SB TMG 601-1012 P1, Rev. 1

SERVICE BULLETIN

Subject: Modification of the GARMIN G1000 interface.

Type affected: Cessna C172-S with TAE 125-02-114.

Figure 3: AWL lines pre modification

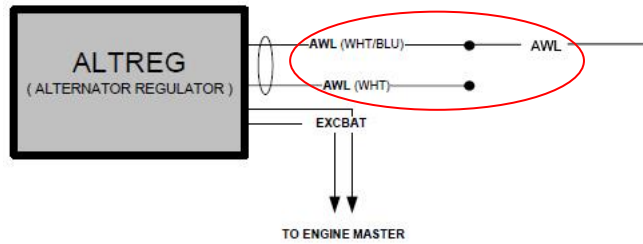
- Look for the white wire of the AWL loom (free wire end) installed behind the PFD.
- Look for the white/blue wire of the AWL loom connected to line AWL.

- Disconnect the line AWL from AWL (WHT/BLU).

Figure 5: Modified electrical installation

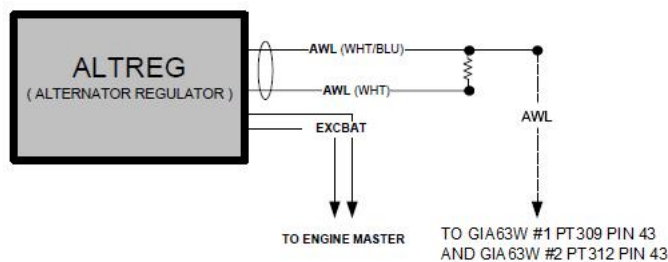
- Install the resistor (item 1), connect as follows:
 - blue UFP blade terminal (male) to wire AWL (WHT/BLU)
 - red UFP blade terminal (male) to wire AWL (WHT)
 - red UFP blade receptacle (female) to line AWL

- Fasten the resistor appropriate and bundle the wires using cable ties.
- Install the Primary Flight Display (PFD) in accordance with the GARMIN G1000 Maintenance Manual.
- Connect the main, excitation and FADEC backup battery.
